Subject: Submittal of Comments on Final Environmental Impact Statement (FEIS) for Interim Storage Partner's (ISP's) License Application for a Consolidated Interim Storage Facility (CISF) in Andrews County, Texas, Docket ID NRC-2016-0231

# Final Environmental Impact Statement Review for Consolidated Nuclear Storage Facility, Andrews County, TX

Figure 2: Cumulative Impact Radii from ISP FEIS (NRC 2021)

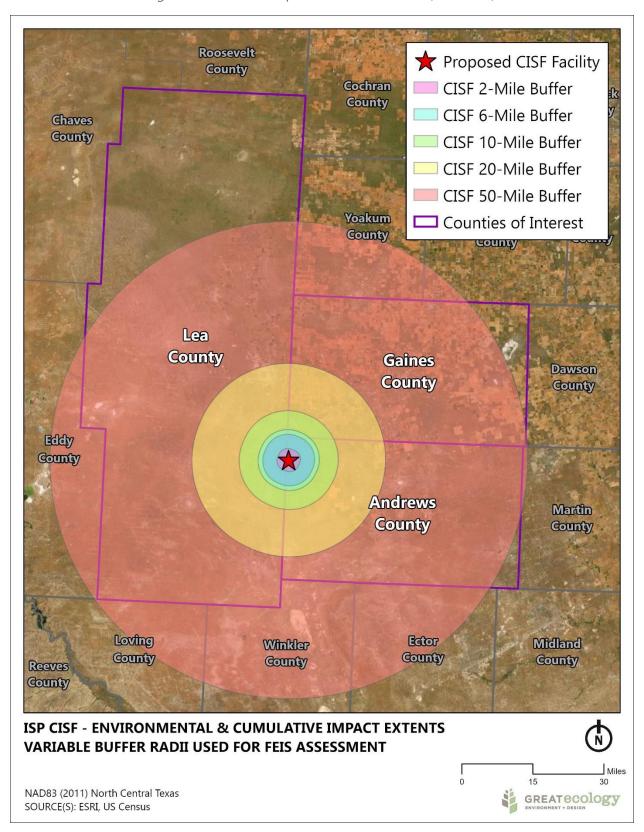
Cumulative impacts under NEPA are defined as "the impact on the environment which results from the incremental impact of the action when added to other past, present and reasonably foreseeable future actions regardless of what agency (Federal or non-federal) or person undertakes such other actions" (40 CFR § 1508.7). The FEIS does not thoroughly evaluate the cumulative impacts of the ISP CISF Project along with all other past, present, and reasonably foreseeable future projects in the project vicinity. Of major concern, many cumulative impacts are evaluated across geographic scales that do not accurately represent the scope and scale of potential impacts or underlying social, ecological, geological, or hydrological processes. FIGURE 2 and TABLE 1 depict all impact radii across categories; of note, these are variable and are not applied across all categories. For example, cumulative impacts to ecological resources are only evaluated within a 5-mile buffer around the ISP site; in contrast, transportation is evaluated within a 50-mile buffer. There is little to no explanation for why ISP chose these radii for ecology and transportation, and if in fact these buffers truly represent cumulative impacts from the site (which, in the case of these two categories, they do not). For these and other radii chosen by ISP, NRC blindly accepted these values without further discussion or evaluation in the FEIS.

Once again, the FEIS arbitrarily identifies a small, 5-mile cumulative impact evaluation radius for wildlife from ISP Project. NRC states that their ecological cumulative impacts analysis is "limited to this radius because ecological resources are not anticipated to influence or to be influenced by the proposed CISF project outside of this area." This statement is not supported by any real scientific evidence and does not consider the wide ranges of several species with the potential to occur onsite. Migratory birds would most certainly be impacted outside of a 5-mile radius from the project, along with any highly mobile species.

Figure 4: Nuclear Transportation Figures from the ISP FEIS. CISF Facility is depicted by red star. **Top:**Decommissioned Nuclear Waste Sites in the United States (Figure 2.2-4). **Bottom:** Location of Railroads in West Texas and Southeastern New Mexico (Figure 2.2-7) (NRC 2021)

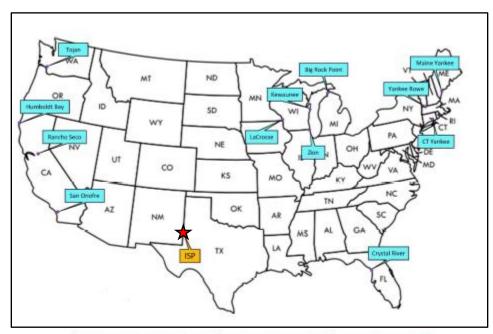
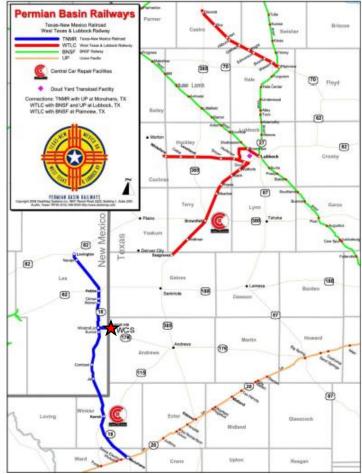
The FEIS also downplays the nationwide extent of where HLW would be arriving from, since HLW is currently stored at nuclear energy facilities dispersed throughout the country. FIGURE 3 shows the locations of nuclear reactor sites across the US, along with the railroad network that would need to be utilized to transport waste currently existing at these sites. Illustrations and figures in the FEIS do not show the true breadth of this problem, and instead separately show the rail network and decommissioned nuclear power plants (FIGURE 4). HLW is spread throughout the country, and the extent of its transportation to the ISP CISF facility has a much larger impact (and would be more than 'incremental') than the FEIS presents. It also ignores what the surrounding local community looks like, and what sensitive receptors could be most impacted. FIGURE 5 depicts several facilities with vulnerable populations in the area (an extrapolation of the rail network presented by NRC in FIGURE 4); many of these sensitive receptors are located quite close to the railroads in the area. Should any accident occur in the future, these people would certainly be impacted quite heavily.

Figure 6: Current Species Ranges for Northern Aplomado Falcon and Pronghorn Antelope

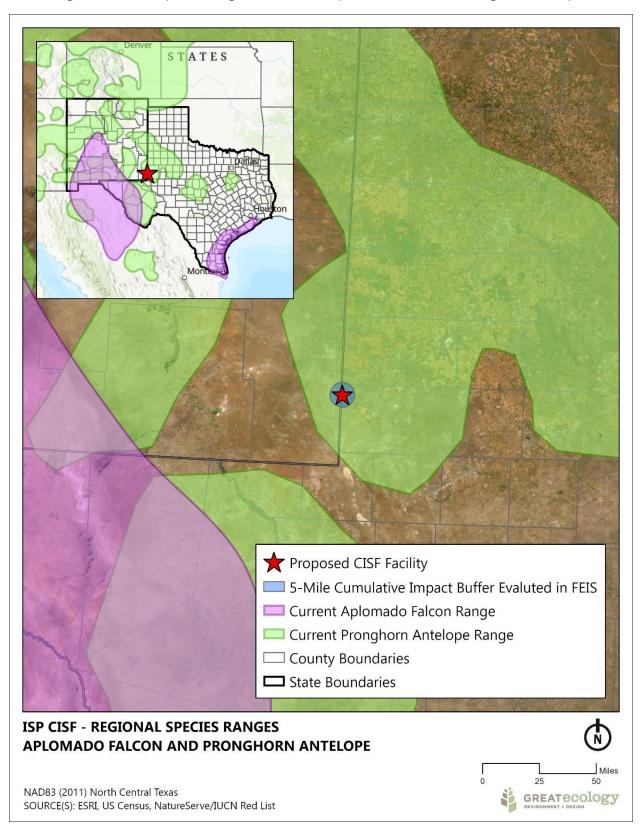
We discuss two species with wide-reaching ranges that were not examined thoroughly as part of the ecological cumulative impacts analysis: the endangered northern Aplomado falcon (*Falco femoralis septentrionalis*), and a regionally important game species, the pronghorn antelope (*Antilocapra americana*). Both species have a much wider reaching range than five miles, which is not captured by the FEIS cumulative impact radius (FIGURE 6).
